This memorandum has been prepared in response to the request for staff memorandum dated January 24, 2012 in the matter of applications for transfer/new water rights No. 73811, 73834, 63-32499, 61-12095, 61-12096, 63-32703, 61-12256, and 63-33344. The following information was requested:

RE: *Response to IDWR Staff Memo regarding the sufficiency of water supply for water right applications and transfers along the I-84 corridor*

January 30, 2013

Figure 9. Comparison of Newton (1991) model zone locations interpreted by IDWR and SPF.

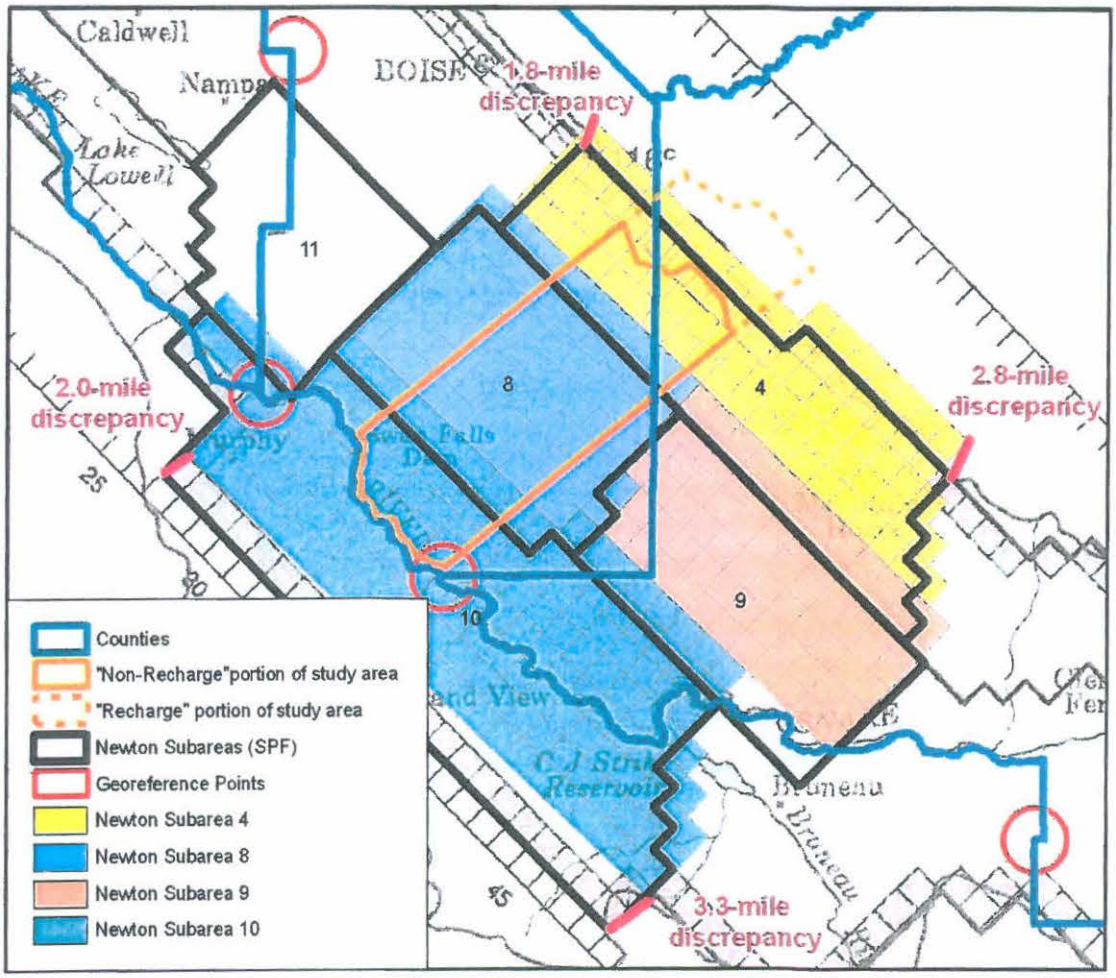
In calculating recharge for the "non-recharge" area using USGS subareas we found a discrepancy in IDWR's geo-referencing of the Newton (1991) subarea map. Correcting this discrepancy resulted in a recharge estimate of 3,000 AF for the "non-recharge" area, which is approximately 340 AF greater than the 2,660 AF recharge volume estimate presented in the IDWR Staff Memo (Table 2).

The geo-referencing discrepancy is illustrated in Figure 9. SPF scanned Figure 17 in the Newton (1991) report and geo-referenced this map using county shapefile polylines (6 points) as reference points. IDWR's geo-referencing was off by distances

of 1.8 to 3.3 miles at four representative corner points (Figure 9). Examples of SPF's geo-referencing points are shown in Figure 10. The net result is that there is a larger portion of USGS subarea 4 and a smaller portion of Subarea 10 in the consolidated cases study area than calculated by IDWR.

Figure 11. Trust area and places-of-use for consolidated applications.

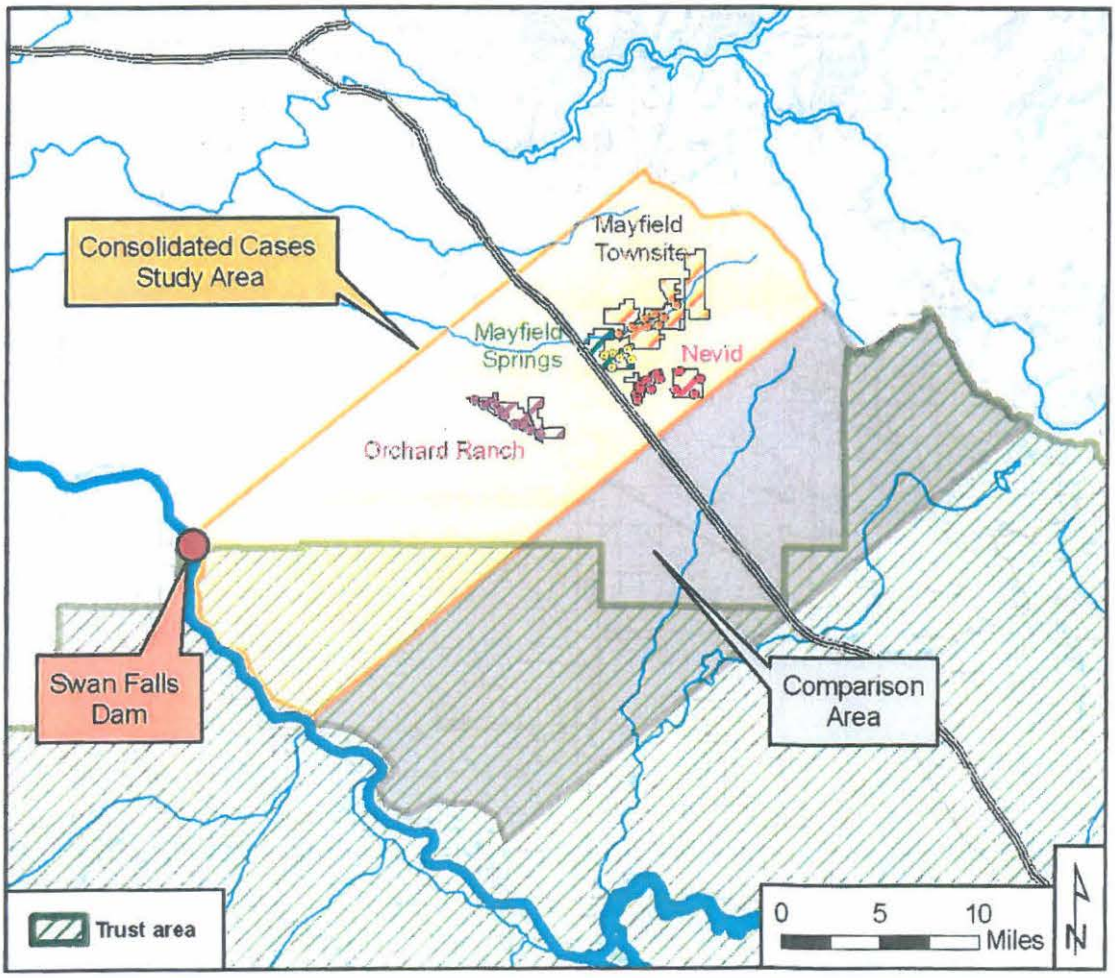
Points of diversion and places of use for the two referenced permits (63-32225 and 61-12090) are not within the trust area boundary defined under IDAPA 37.003.008 (Figure 11). These applications were not protested based on concerns regarding trust water impacts. Consideration of trust water impacts was therefore not required for the processing of these permits. Furthermore, points of diversion and or places of use for applications that are part of this consolidated administrative process (Applications 63-32499, 61-12095, 61-12096, 63-32703, 61-12256, and 63-33344) also lie outside of the trust area (Figure 11).

Figure 12. Snake River minimum flows.

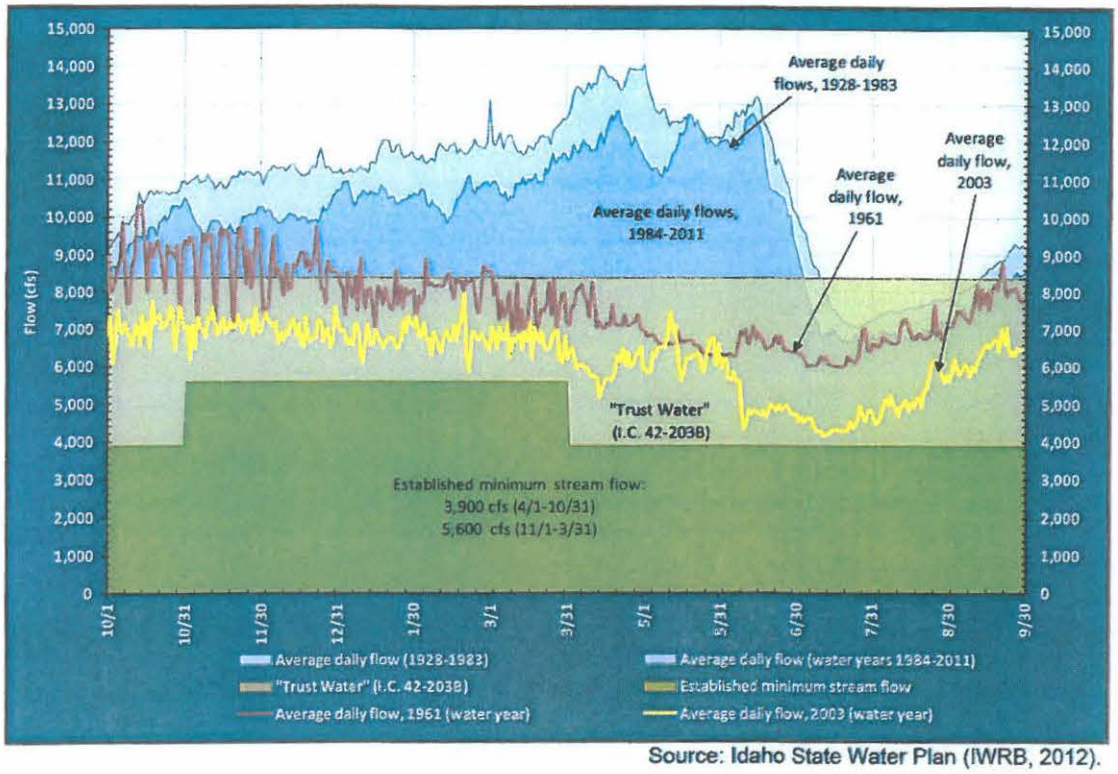
It is important to recognize that average Snake River flows remain well above established minimums. Average daily flows since 1984 (Figure 12) have not only been greater than established minimum flows, but during substantial portions of the year have been greater than the 8,400-cfs generating capacity at Swan Falls Dam. Approval of consolidated-case applications and transfers would represent absolutely no impact to hydroelectric generation during times of the flows greater than 8,400 cfs.

Recent low-flow years (e.g. 2003 – see Figure 12) have seen average daily flows less than 8,400 cfs (but more than minimum flows). However, hydropower rights

Based on the hydrographs in Figure 12, it appears unlikely that a future dip below established minimum flows, if it occurs, would have a long duration. Non-approval of the proposed consolidated-case applications and transfers because Snake River flows may dip below established minimums for a short period of time sometime in the future would preclude the full economic development of the study-area groundwater resource as provided under Idaho Code § 42-226. Furthermore, attempting to prevent a dip in minimum flows by disapproval of these consolidated applications and transfers would be futile because of the relatively small amount of water involved[14].
